HISTORIC ENGLAND
CIVIL & STRUCTURAL ENGINEERING TEAM
INTERNAL MEMO

Subject: St Stephens, Rosslyn Hill, Hampstead, London

To: Ian Harper (HE, London Office) **cc:**
From: Bridget Drake-Wilkes **Tel:** 07747 743 081
(Senior Engineer)
Date: 9th September 2015

Figure 2. Slipped slates on main roof south elevation

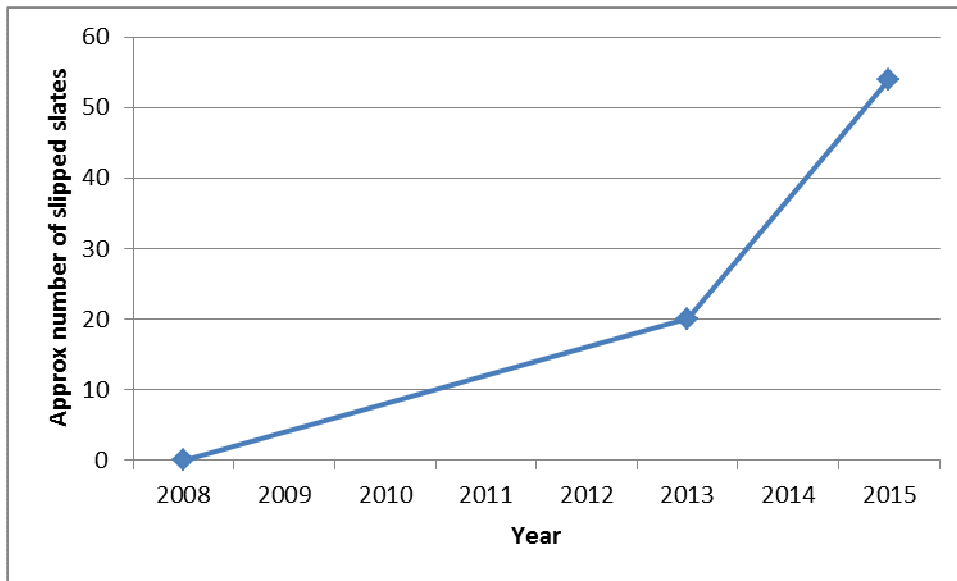
- 4.7 The lower roofs to the north and south isles were reroofed and the slipped slates on the main roof reset with tingles in approximately 2008. You visited site in December 2013 when on the south elevation approximately 20 slates had slipped. On our site visit in August 2015 we observed 54 slates had slipped in the same section of roof. It is not known when the main roof was last (if ever) renewed. I believe that the main roof has suffered from corrosion of the nails (nail sickness), which manifests itself by means of slipped slates.

4.8 Figure 2 shows the number of slipped slates observed graphically since it was last reset. It is possible that the vibration from the adjacent works may have accelerated the rate at which slates have slipped. Although exponential deterioration would be expected under normal environmental conditions as more of the roof structure becomes exposed.

- 7.3 It would be prudent for the trustees to consider the timescale to undertake renewal of the main roof, particularly the south elevation as with more slates slipping, the risk of damage to the fabric of the building increases.

Photo 10. Main roof, south elevation areas of slipped slates.

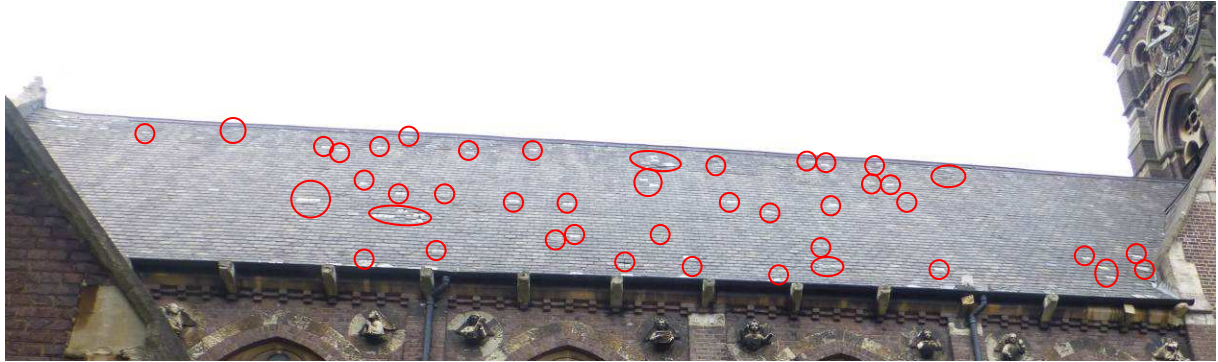
3.7 On the main roof south elevation 54 slates had slipped (Photo 10). On the main roof north elevation a few slates had slipped adjacent to the tower (Photo 11).
